Remediation by Natural Attenuation Treatability Study for OU-4 (Site FT-1)

Shaw Air Force Base Sumter, South Carolina

Subject: Submittal of the Final Remediation by Natural Attenuation Treatability Study

This letter provides responses to second-round comments submitted to Parsons ES by the Air Force Center for Environmental Excellence Technology Transfer Division (AFCEE/ERT) regarding the subject report. On 18 June 1999, Parsons ES submitted to AFCEE/ERT the first response to comments letter regarding the TS report for OU-4 at Shaw AFB. AFCEE/ERT reviewed the 18 June 1999 response to comments letter and submitted additional comments/questions on 18 August 1999. Responses to these second round comments were prepared by Parsons ES and are presented herein.

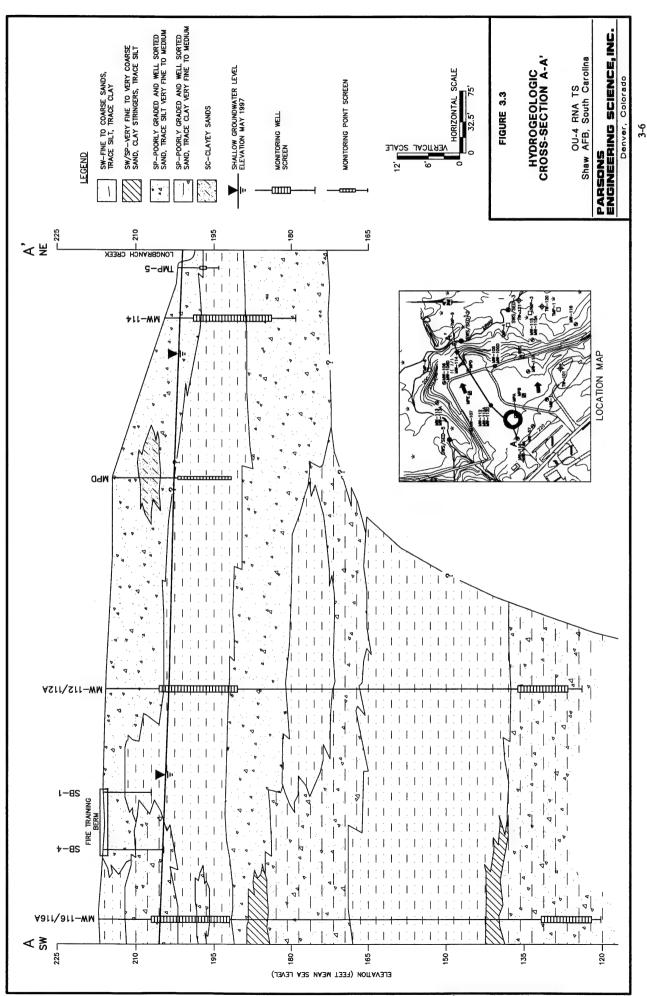
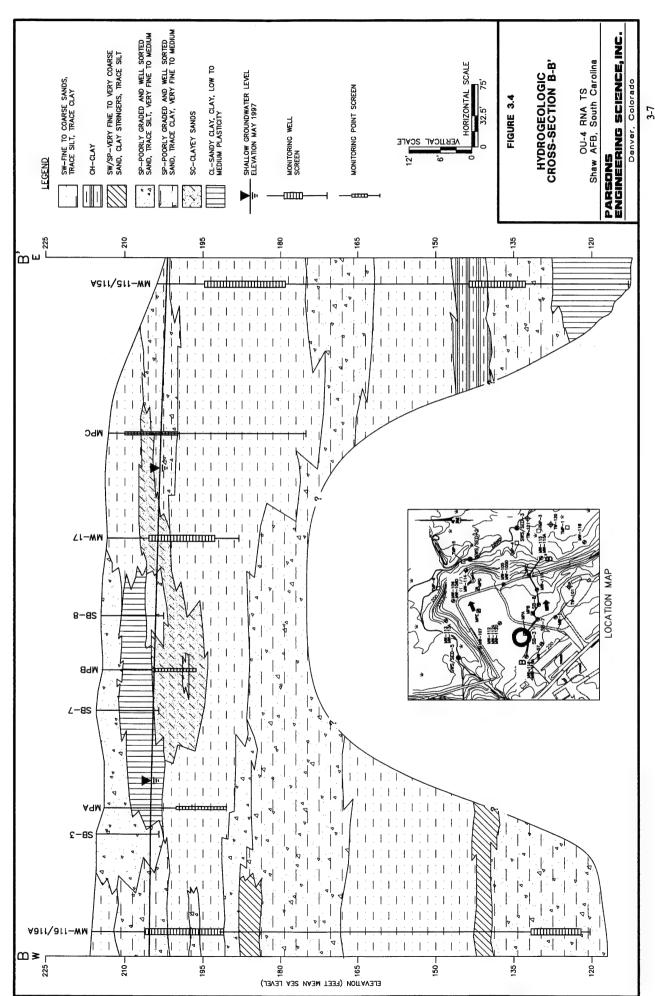
- Comment 5: Pages 3-7 and 3-8, Figs 3.3 and 3.4: Suggest adding the vertical exaggeration specifications for the cross sections.
- **Response 5:** Agreed. References for the vertical exaggeration in Figures 3.3 and 3.4 were added.

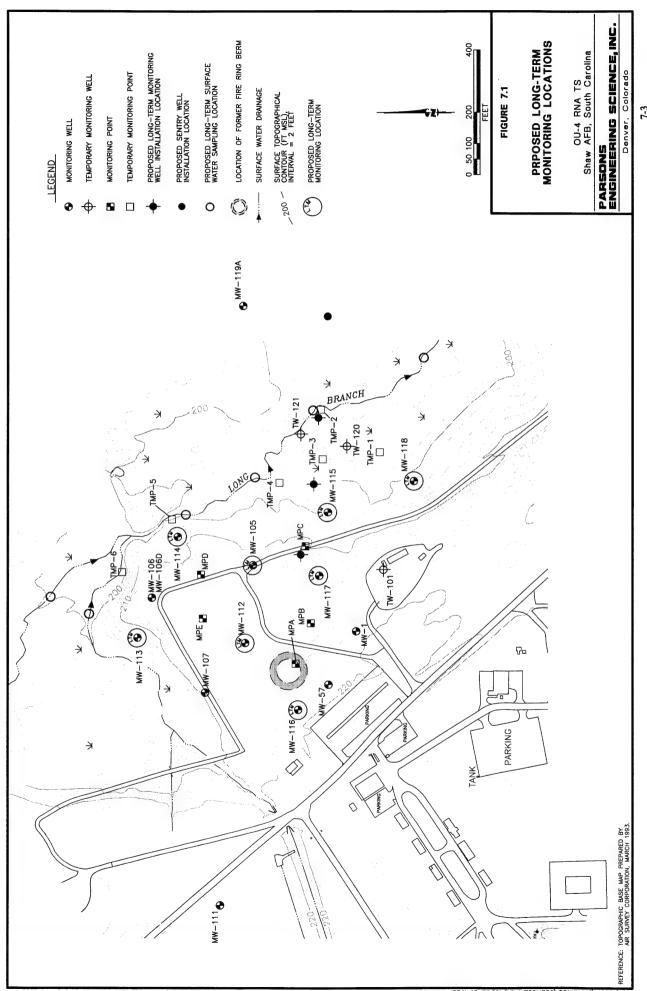
- Comment 16: Page 7-2, Sec. 7.2.1: MW-112 is listed as a proposed LTM well; however, it is not depicted as a proposed LTM well on Figure 7.1.
- **Response 16:** Thank you. Monitoring well MW-112 was marked as a proposed LTM well in Figure 7.1.

well is not depicted on Figure 7.1. This inconsistency should be resolved.

b. Par. 2, Sent. 1: The recommendation of four proposed new monitoring wells contradicts Section 7.2.1 and Figure 7.1 which contain three proposed LTM wells. This inconsistency needs to be resolved.

- Response 14: Parsons ES proposed four new wells at OU4. These four proposed wells include three LTM wells and one sentry well. The proposed sentry well location was accidentally omitted from Figure 7.1 and will be replaced in the final document. Tables 6.3 and 6.4 were clarified by the modification of the first line of descriptive text in each table from, "Design/construct four LTM wells in 1998," to, "Design/construct three LTM wells and one sentry well in 1998." Furthermore, the costing section for Alternative 1 (Section 6.4.1.3) was amended to include a reference to the construction of a sentry well.
